**Application Reference:- M/133/17/PL**

**'Demolition & erection of 1 No. dwelling to existing ground floor slab  
Little Thatch, 93 Middleton Road, Middleton on Sea PO22 6DW'**

We refer to the above Planning application and are writing to register our Objection to the proposed development. Our property, known as Roebuck Cottage at no. 97, is adjacent to the eastern boundary of the Application site (despite the road numbering).

An extract from the Village Design Statement which highlights the sensitive relationship the existing cottage has with our property

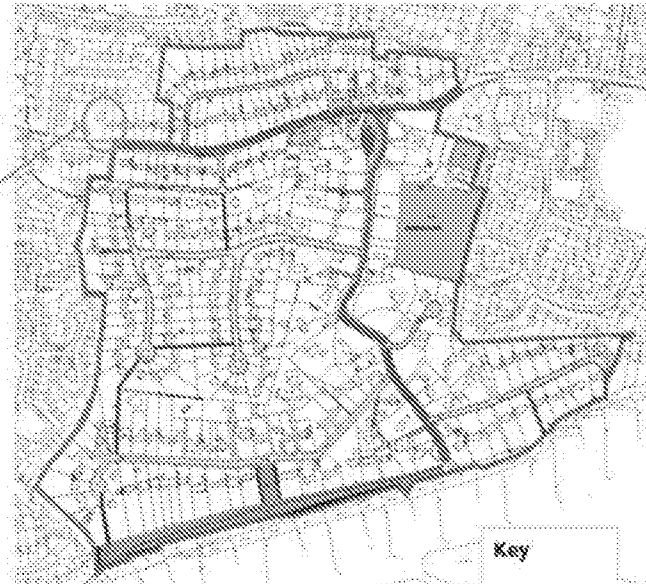
The dwelling at no. 93 is set back from the public highway much more than the others nearby on the northern side of Middleton Road. This alignment is of particular relevance because it results in any developments having a greater impact on the most sensitive area of adjacent gardens than would otherwise be the case - and especially ours. An extract from the Village Design Statement (VDS) is included below to show the position of our house in relation to no. 93.

Not only is no. 93 set back much further from the highway than our house, it is also in very close proximity to our mutual boundary because it is not centrally located within the plot.

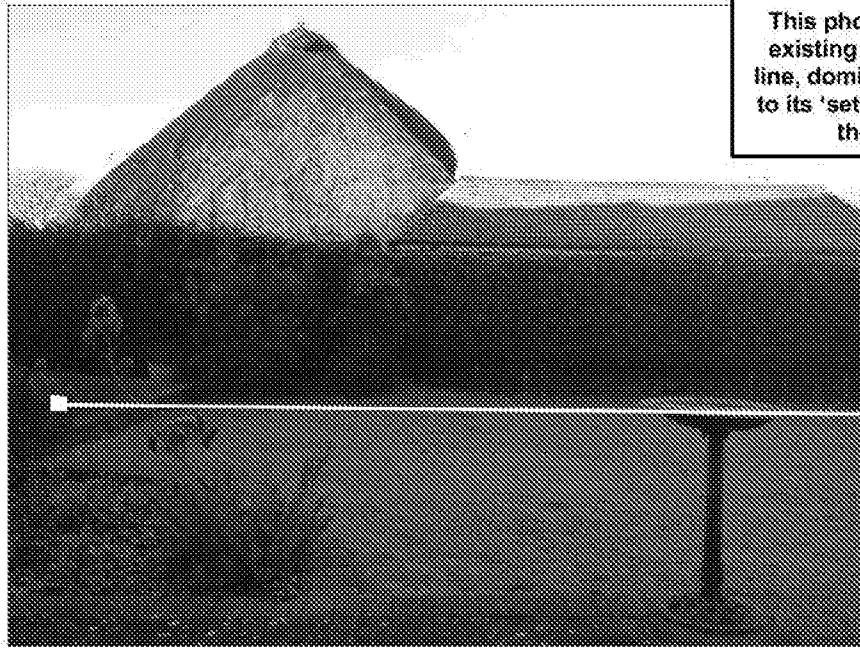
Focusing on the elevation facing our property, the configuration of the roof would look bulky and particularly awkward. The substantial increase in the height of the side elevation, as well as the eaves and ridgeline of the roof itself, would be particularly dominating. The new two-storey house that be built would have an over-bearing presence on us, resulting in a loss of outlook and light levels, especially in the afternoon during the months when the sun is lower in the sky.

Currently there are only ground floor windows facing us at no. 93, hidden behind the fence (which is not acknowledged in Section 15 of the Application Form). The proposal includes three more windows above on the upper levels. The two rooflights would serve Bedroom 4 and the stairway area leading to it. Neither of these appear to be necessary and we consider them to be un-neighbourly. The window serving the un-named room (which is actually simply the en suite end of the bedroom) is also un-neighbourly and adds to the presence of being continually overlooked. We are also concerned that an alternative internal layout (which wouldn't be subject to Planning permission) could exacerbate the loss of privacy in the future.

Due to the duplication of rooms, as mentioned earlier, there would be no need for the occupiers of the annexe to use any of the facilities within the main house. The single connection point (on the ground floor) could easily be blocked off and therefore, in effect, a second, elongated house is being proposed alongside the fence. This intensification would certainly have an intrusive presence, particularly as the current building is less than one metre from the fence boundary.

In terms of loss of privacy, we don't feel that it relates solely to overlooking from windows - it also involves activity and disturbance in close proximity to private garden areas. In this case it would be right up against our boundary - starting from the rear elevation and patio and running northwards for the entire length of our garden. In particular the entrance door to the annexe / second house would cause disturbance the most sensitive area of our property. We feel that all of this is unacceptable.

- (1). The bedroom window on the east elevation be replaced with a sky light similar to the one at the other end of the room. This will still let good sunlight into the room but won't then overlook our private seating area.□*

- (2). The roof light in the hallway be replaced by glazing around the new entrance door, or if a roof light must be fitted, for it to be fitted with the highest level of obscurity and severely limited in size to sustain the privacy into our kitchen diner and private seating area.□*

- (4) A condition is imposed which prohibits any additional fenestration / glazing on the east elevation (or amendments to those shown on the drawings).*
